EPR0039: Optional Firm Access Testing and Design

Submission Paper to AEMC for:

**Optional Firm Access Testing and Design
Supplementary Report on Pricing**
(AEMC Reference: EPR0039)

Figure 1: Impact of short term, long term zone growth factors and long term growth rate on demand forecast

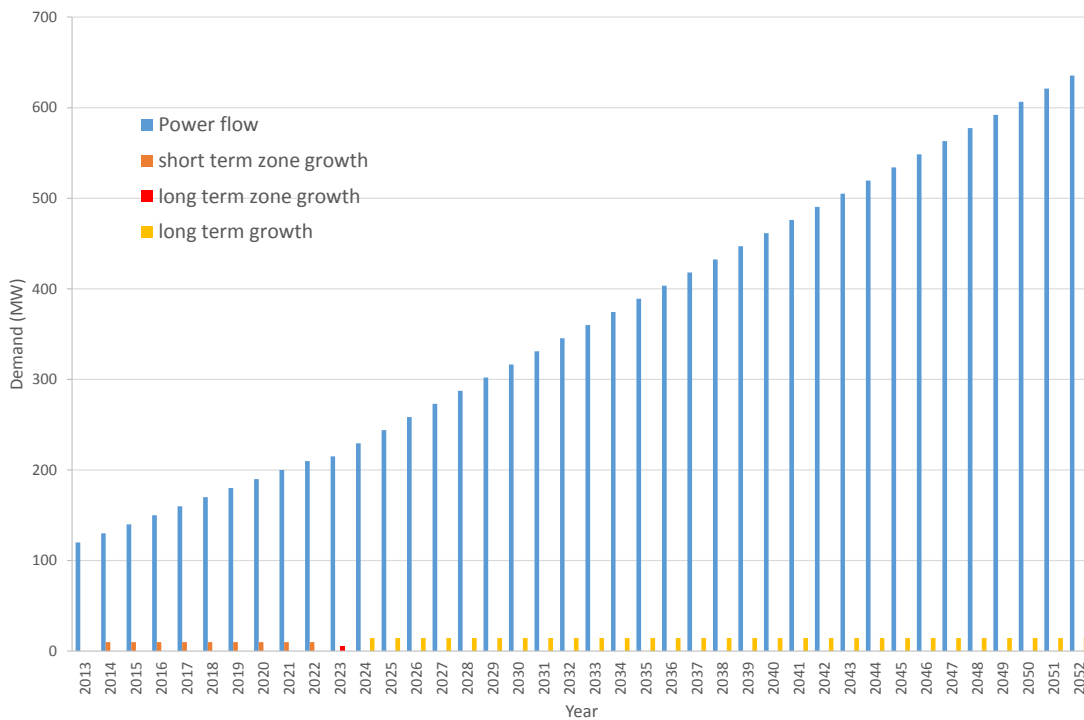
This arrangement raises some questions:

1. It is not easy to work out the contribution of forecast-demand and short-term zone growth to a particular node.
2. The long term zone growth can only influence the demand at 2023. It is believed that this factor will not have any “long term” effect as the future demand is controlled by the annual increase rate of the transmission line power flow instead.
3. From 2024, the annual growth is based on a percentage of the rating of a particular line type⁵. This will create a mismatch in the load flow. For illustration, Figure 2 shows a bus with one incoming line and one outgoing line. In the first 10

Figure 2: Illustration of mismatch in power flow

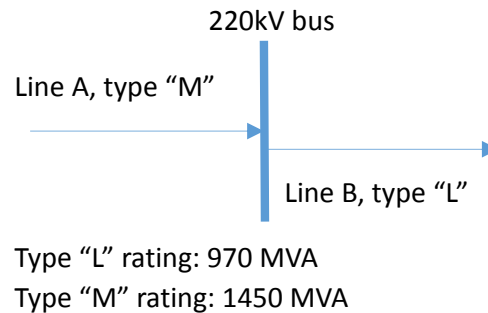
year period, the power flow into the bus will be equal to the power flow out of the line as the dc loadflow program is used to recalculate the power flows. However, if we set the long term growth rate to be 1% of the rating of that particular line type, the increase in power flow in line A will be 0.97 MW and that in line B 1.45 MW in 2024. This creates an impossible power flow situation for the network.

Figure 4: PowerFactory solution (SMIB)

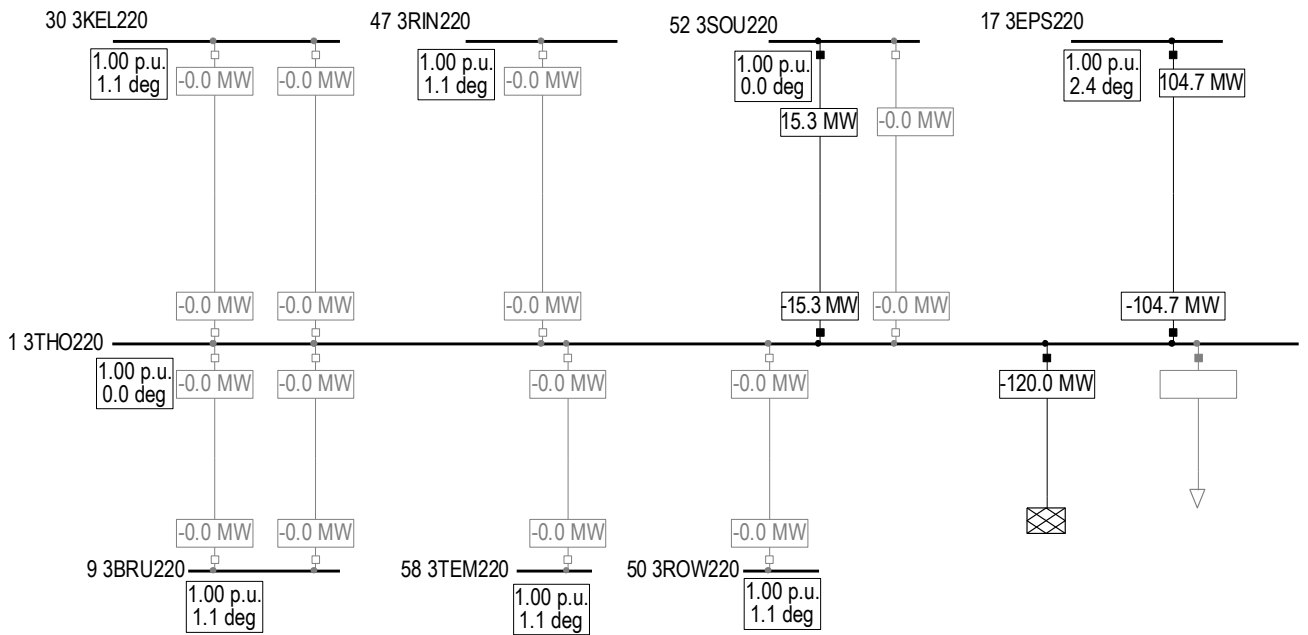
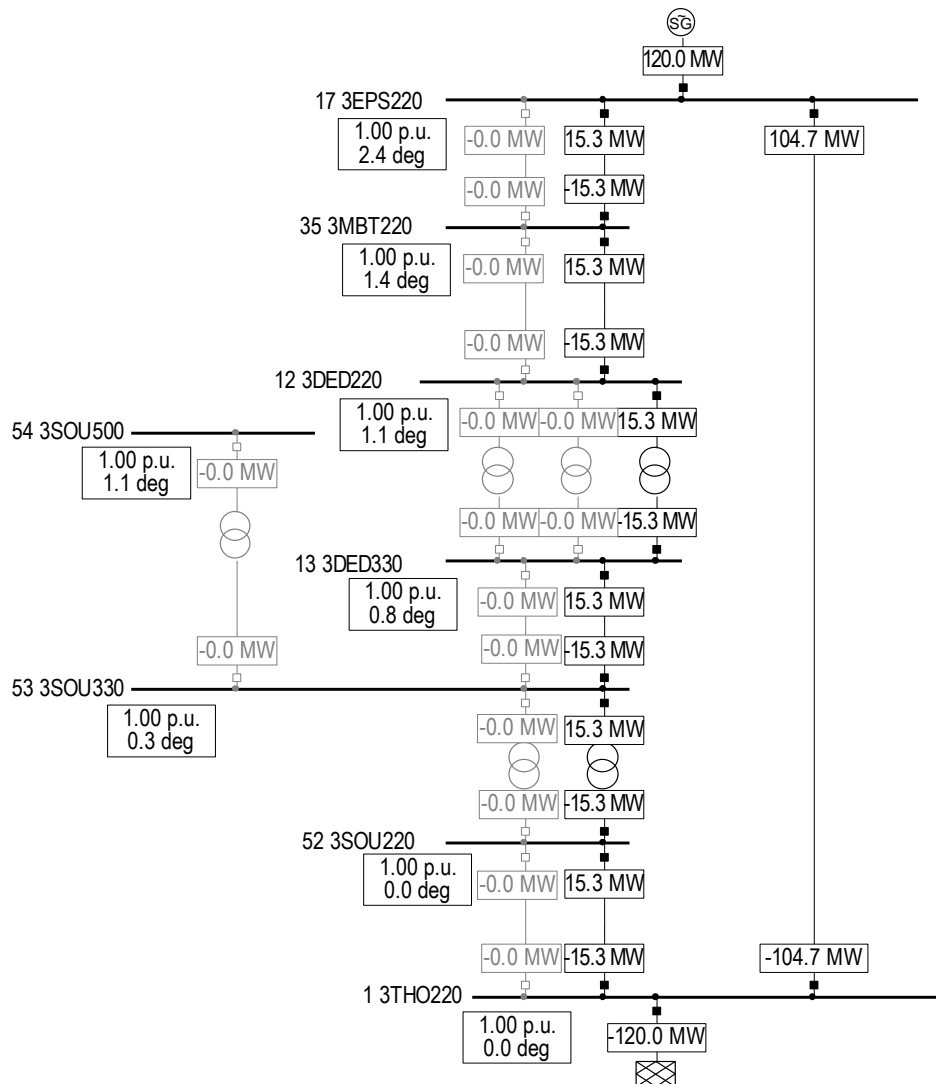
A single-machine-infinite-bus SMIB case has been used to illustrate the findings in Section 2.2.1. The SMIB case is made by modifying the existing Victorian system in the prototype as follows:

1. Reduce all firm access generations in the aemc-access.csv file to 0 MW and Eildon PS has 120 MW firm access;
2. Reduce all forecast demand to 0 MW in the aemc-demand-forecast.csv;
3. Force the power flow from Eildon PS to Thomastown (RRN) through the direct EPS220-THO220 line and EPS-MBT-DED-SOU-THO path by blocking the other possible branches, i.e. by increasing the impedances of the relevant lines and transformers to infinity. Figure 3 shows the equivalent setup in PowerFactory.

Table 6 compares the load flow results calculated by the prototype against the PowerFactory results. It is clearly seen that the PowerFactory case can only align with the prototype results by switching off all the parallel lines and transformers. Figure 4 shows the equivalent setup in PowerFactory and the corresponding load flow results.

Figure 5: 3-bus example and loadflow solution

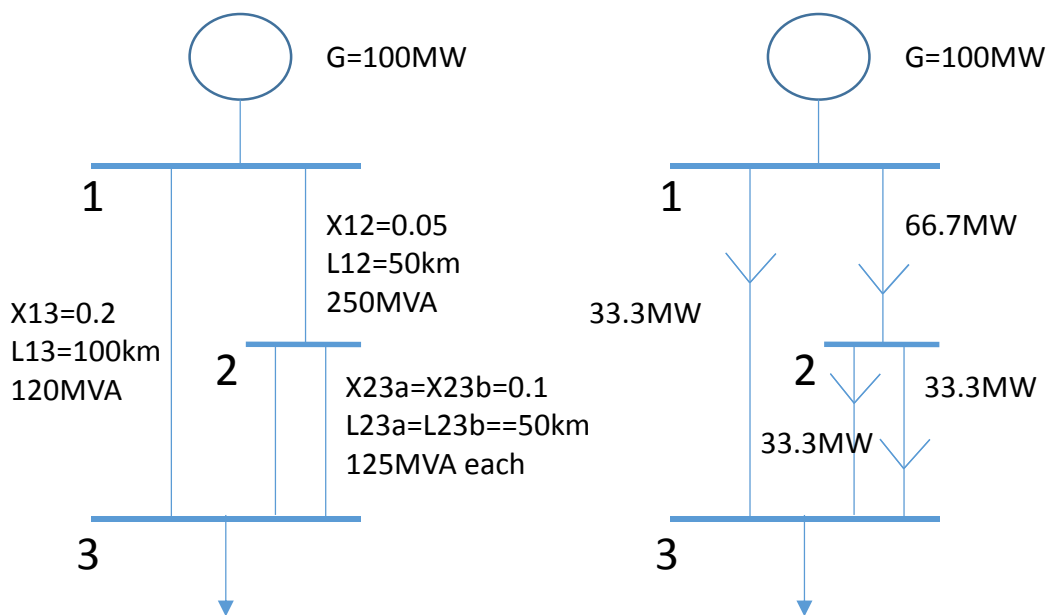
In order to compare the post-contingent power flows and the security adjustment results, a simple 3-bus example was constructed using the prototype. The single line diagram of the example and the pre-contingent loadflow solution are shown in Figure 5. The data used in this example is provided in Appendix A. The theoretical N-1 post-contingent power flow through the lines are shown in Table 9. The post-contingent power flows through the lines calculated by the prototype are shown in Table 10. It is shown that:

- The post contingent spare capacities of lines 1-3, 1-2 and 2-3a are similar to the theoretical values but not exact; and
- The post contingent spare capacities of lines 2-3a and 2-3b are not the same while the properties of these two lines are identical.

It is unclear how the contingency analysis of the prototype works. It is important for the next release of the prototype to provide sufficient examples to demonstrate this function. It is worth mentioning that this contingency analysis function is common in most of the established power system software such as PowerFactory and PSS/E. These programs

Figure 6: New loadflow solution of the 3-bus system

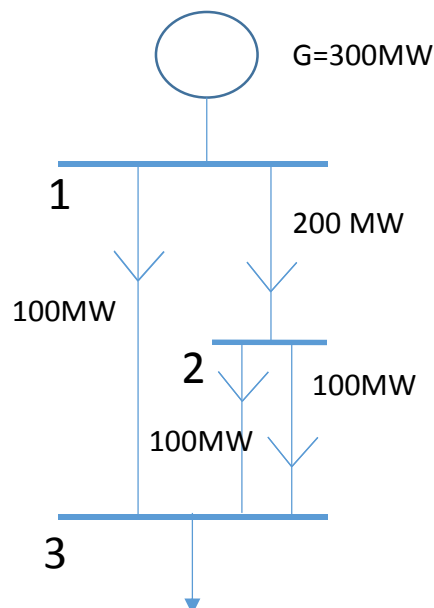
The 3-bus example in Section 2.5 is used for checking the access pricing results. An additional 200 MW of firm access was requested at Bus 1, making 300 MW of power flow from Bus 1 to Bus 3. The new power flow solution is shown in Figure 6. With the post-contingent power flow exceeding the rated capacity of 120 MVA, an upgrade of Line 1-3 is required. According to the prototype solution, the lumpiness of Line 1-3 is 3, and the line type of Line 1-3 has a capacity of 200 MVA. Therefore, a line of 66.7 MVA will be added in parallel with Line 1-3, making the total capacity = 186.7 MW.

The deep connection cost (DCC) will be the amount of money spent divided by the lumpiness of the line (which is 3) = \$16.67/kW. This is similar but not exactly equals to the calculated cost.

It is uncertain how the LRIC is calculated in this case.
